Access Compliance Report

Public Rights-of-Way

(Curb Ramps)

Intersection ID: 54260	Main Street: BALLANTYNE COMMONS PY	Cross Street: BLACK FOREST LN	Location:	S
ADA ID: 34600B28FB40	Ramp Type: Perp	Initial Pass/Fail: Fail	Overall Compliance: No	Severity Score: 25
Codes/Mitigation Info/Possible Solution		Field Measurements/Component Compliance

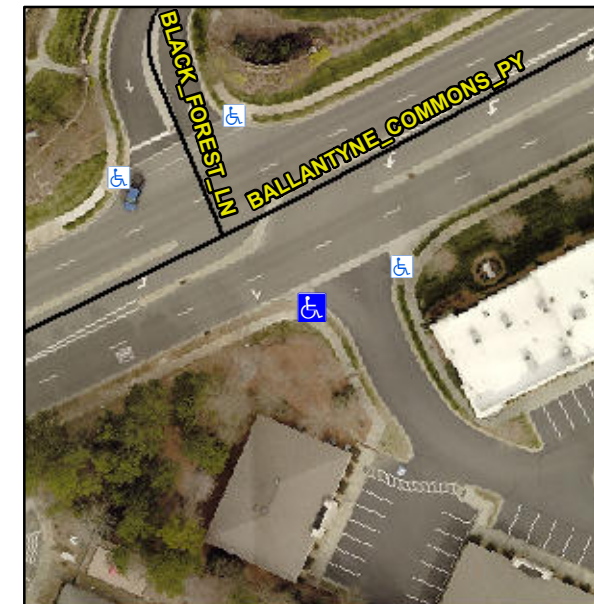
Not Found, R304.5.3

Compliance	Description	Data	Compliance	Description	Data
N/A	Ramp Length (in)	51.0	Yes	Ramp Slope (%)	7.0
Yes	Ramp Width (in)	49.0	No	Ramp XSlope (%)	11.1
N/A	Flare Type LT	N/A	N/A	Flare Type RT	N/A
N/A	Flare Slope LT (%)	N/A	N/A	Flare Slope RT (%)	N/A
N/A	Flare Traversable LT?	N/A	N/A	Flare Traversable RT?	N/A
N/A	Landing Length (in)	N/A	N/A	DWS Provided?	N/A
N/A	Landing Width (in)	N/A	N/A	DWS Contrast?	N/A
N/A	Landing Slope (%)	N/A	N/A	DWS Length (in)	N/A
N/A	Landing X Slope (%)	N/A	N/A	DWS Full Width?	N/A
N/A	Landing Curb? (Y/N)	N/A	N/A	DWS Offset (in)	N/A
N/A	Shared Landing?	N/A			
N/A	Gutter Ponding?	N/A	N/A	Gutter Slope (%)	N/A
N/A	Gutter Lip Ht (in)	N/A	N/A	Gutter X Slope (%)	N/A
N/A	Painted X Walk1?	No	N/A	Painted X Walk2?	N/A
	X Walk 1 Direction	To E		X Walk 2 Direction	N/A
N/A	X Walk 1 Width (in)	N/A	N/A	X Walk 2 Width (in)	N/A
	X Walk 1 Slope (%)	4.2		X Walk 2 Slope (%)	N/A
	X Walk 1 X Slope (%)	7.7		X Walk 2 X Slope (%)	N/A

Remove & Replace Entire Ramp.
